## Pathways for Decarbonizing Transport towards Carbon Neutrality in China

Pathways for Decarbonizing Transport towards Carbon Neutrality in China

# PIF

Figure 5: Flowchart for Indirect GHG Emission Reductions

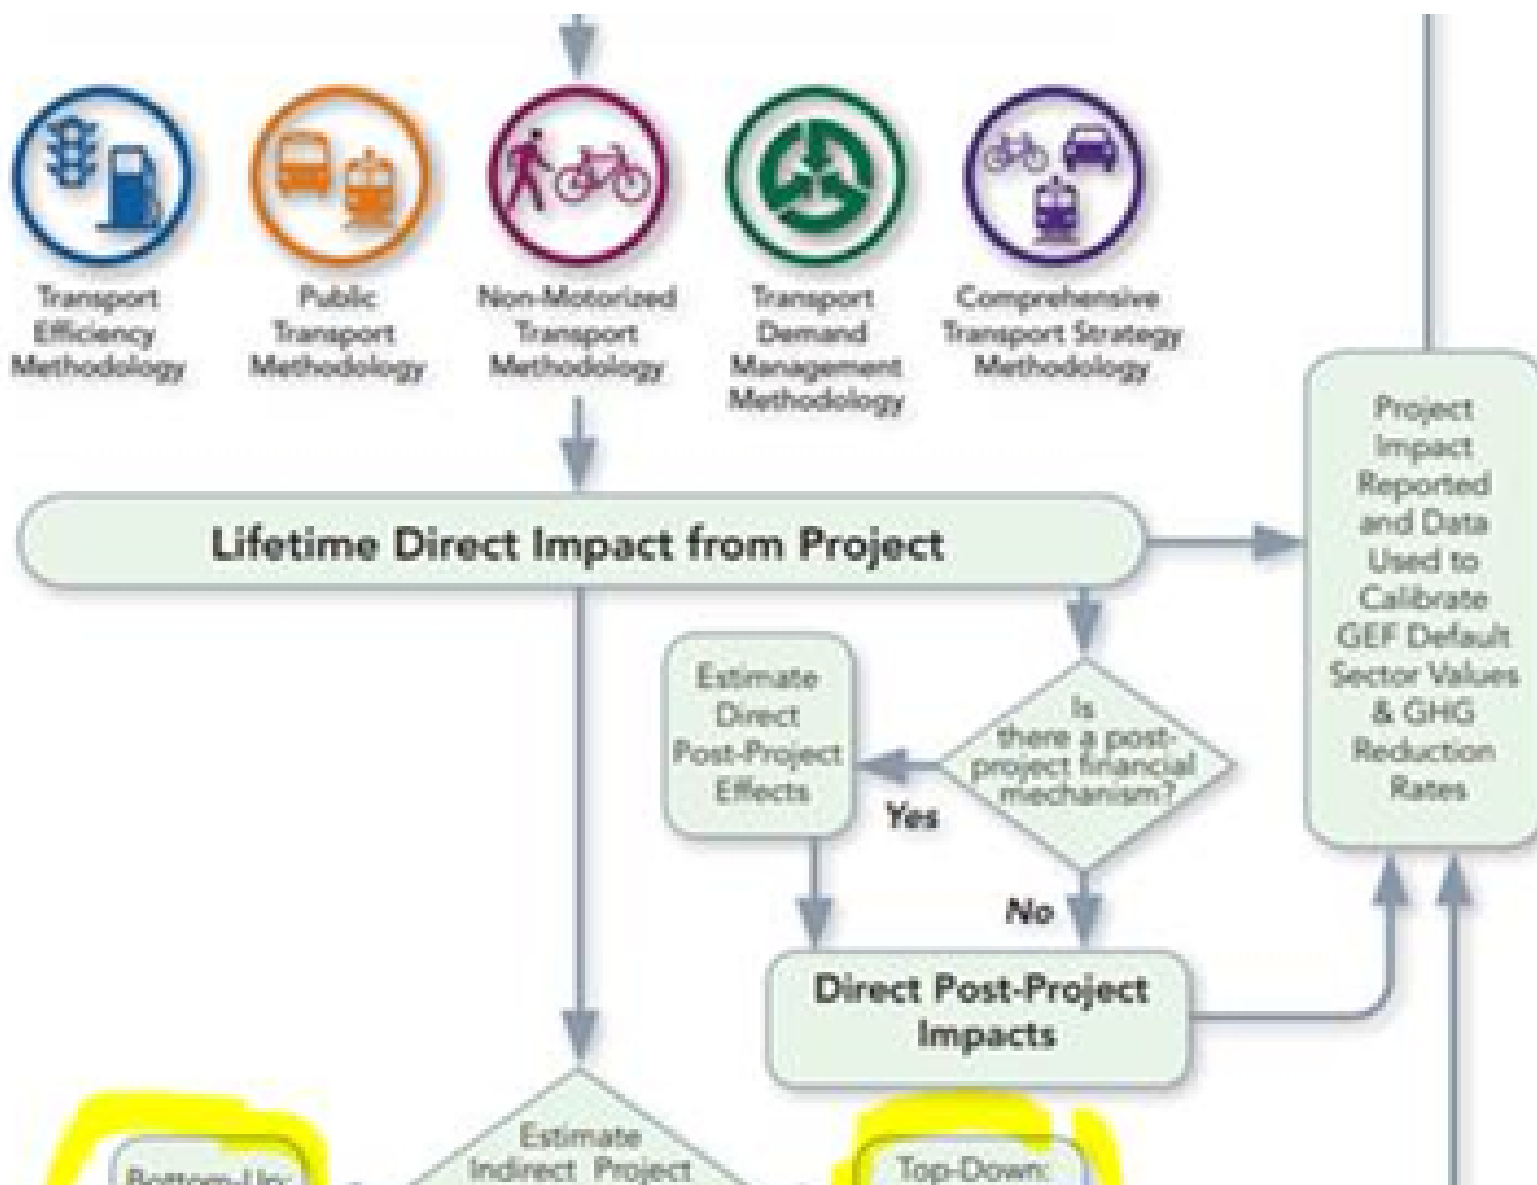
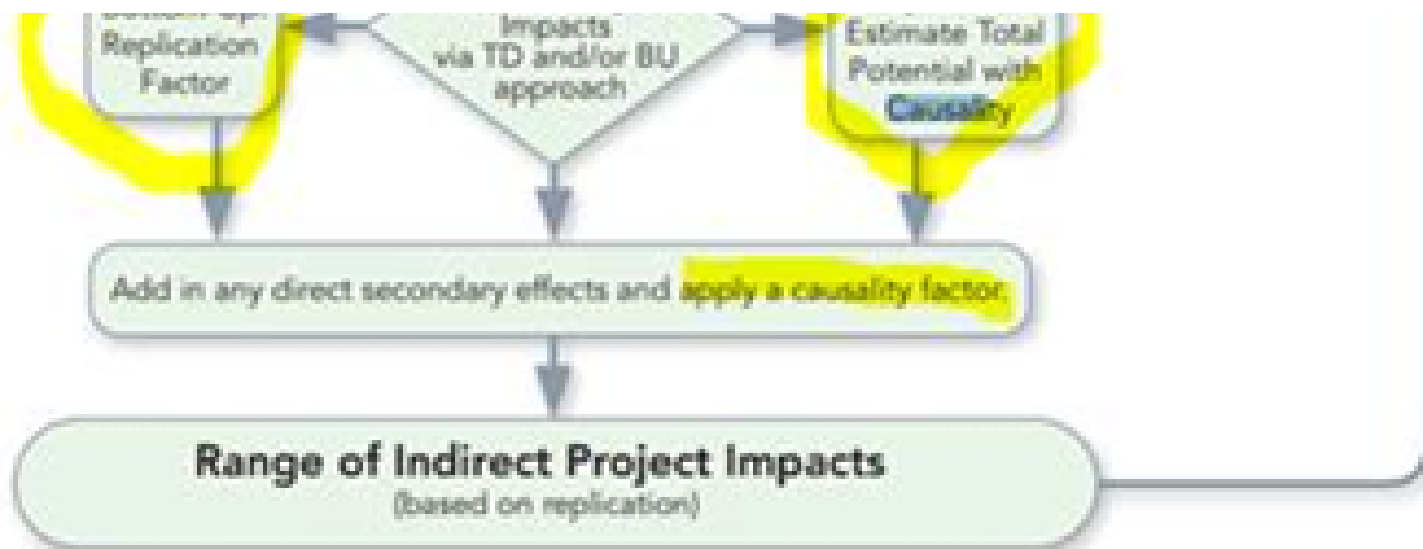
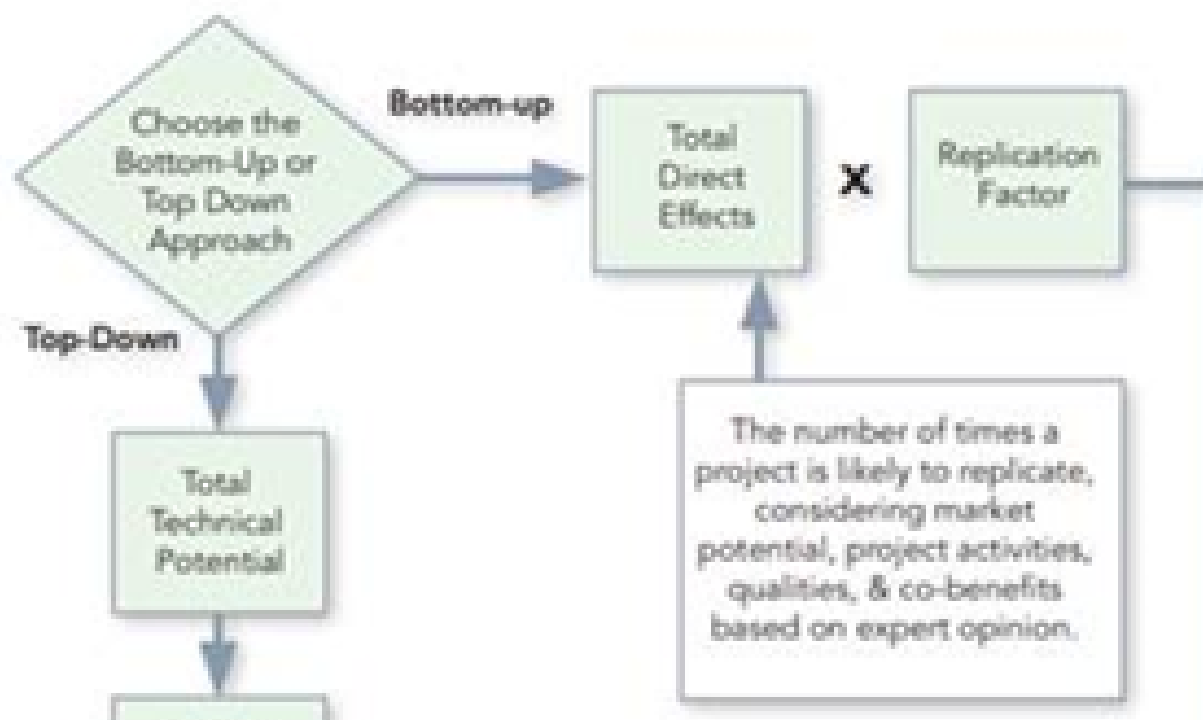
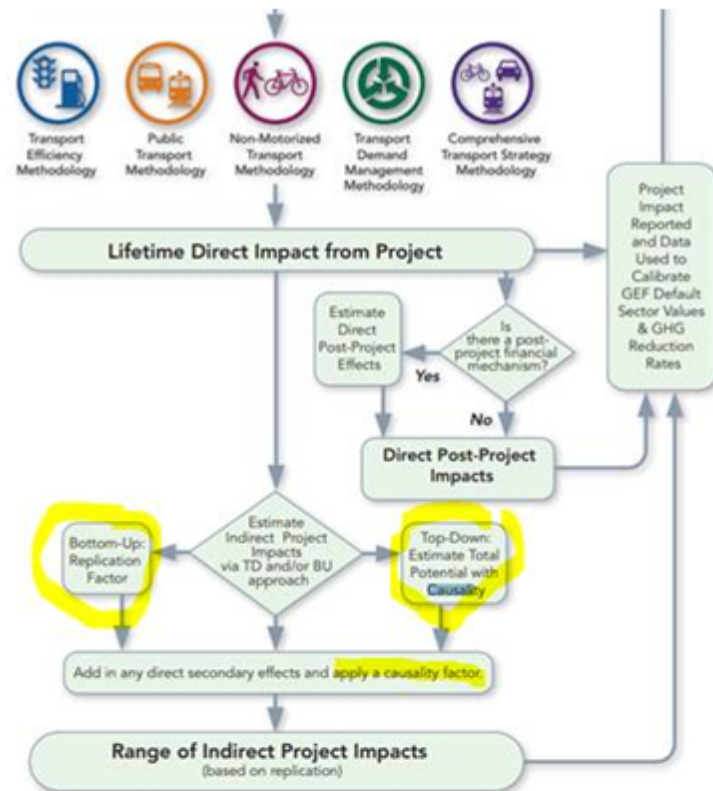
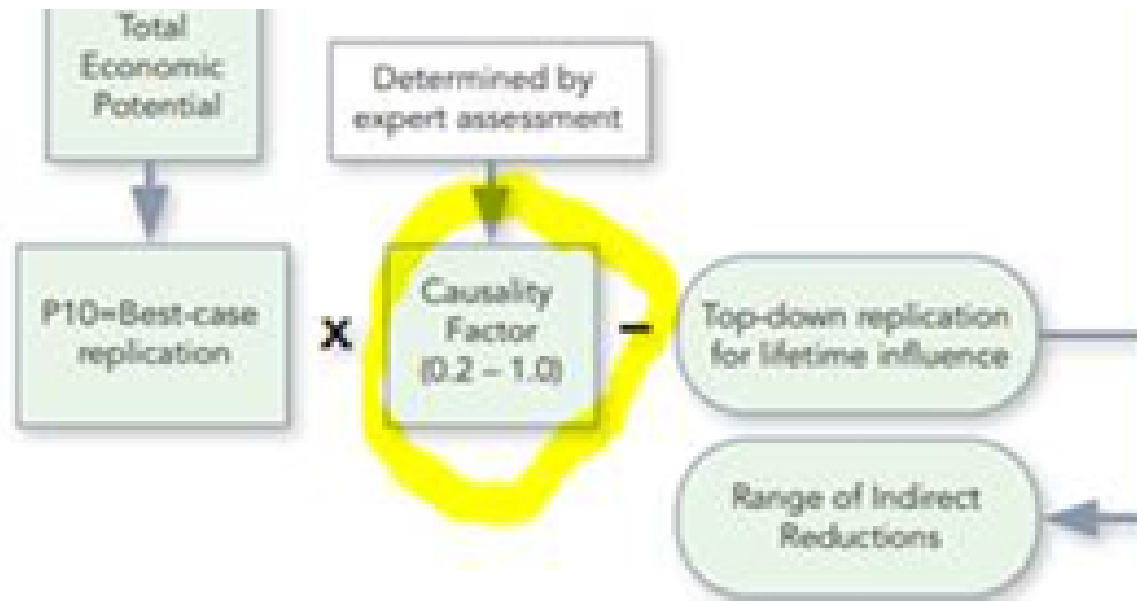
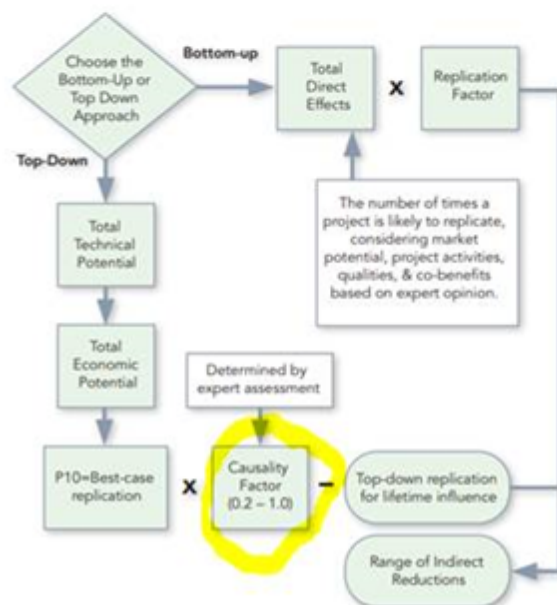
4/19/2021 MY:

At the PPG stage, please undertake more detailed analysis on GHG accounting. Please be aware that the GHG direct emission reductions are accounted only from inside the sub-pilot projects, namely the selected ports. For the consequential or indirect GHG emissions, please follow the guideline of the GEF methodology. Here is a reference of the methodology framework:

We have revised the indirect emissions estimate to show a level 1 GEF causality factor. The revised indirect emissions reduction estimate is 19.4 million tons. We have revised the portal entry and other documents accordingly.
